INDRY NOTICES AND REPORTS ON WELLS

Do not use this form for proposals to SE abandone well. Use form 3160-3 (APL	If Indian, Allottee or Tribe Name  7. If Unit or CA/Agreement, Name and/or No. 8910138170	
SUBMITINE PLICATE - Other instructions on reverse side.		
Type of Well		8. Well Name and No. MLMU 184
2. Name of Operator Contact: DAVID STEWART OXY USA INCORPORATED E-Mail: david_stewart@oxy.com		9. API Well No. 30-025-27483-00-S1
3a. Address P O BOX 4294 HOUSTON, TX 77210-4294	3b. Phone No. (include area code) Ph: 432-685-5717 Fx: 432-685-5742	10. Field and Pool, or Exploratory LANGLIE
4. Location of Well (Footage, Sec., T., R., M., or Survey Description)		11. County or Parish, and State

OXY USA WTP LP - Proposed Myers Langlie Mattix Unit #184 API No. 30-025-27483

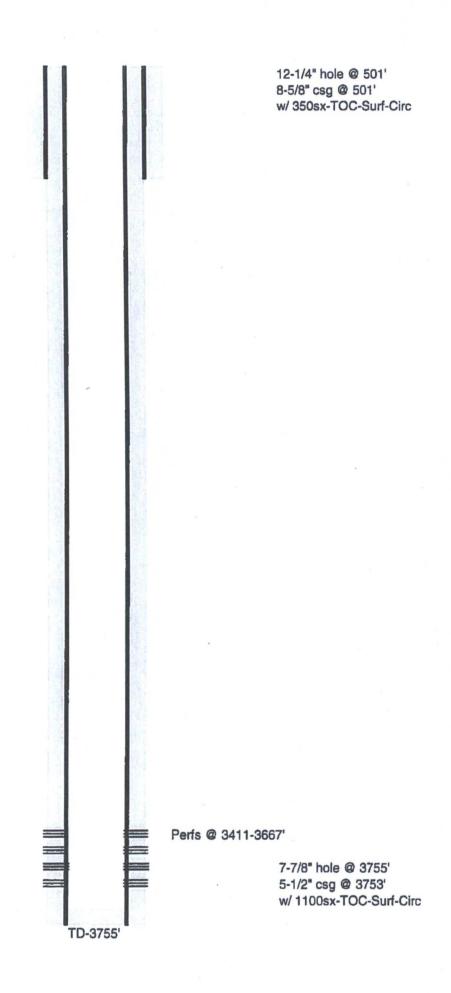
70sx @ 551'-Surface

/250-1100 25sx @ 1150-1600' WOC-Tag TOS 1190'

35sx @ 2730-2450' WOC-Tag

CIBP @ 3361' w/ 25sx to 3210'
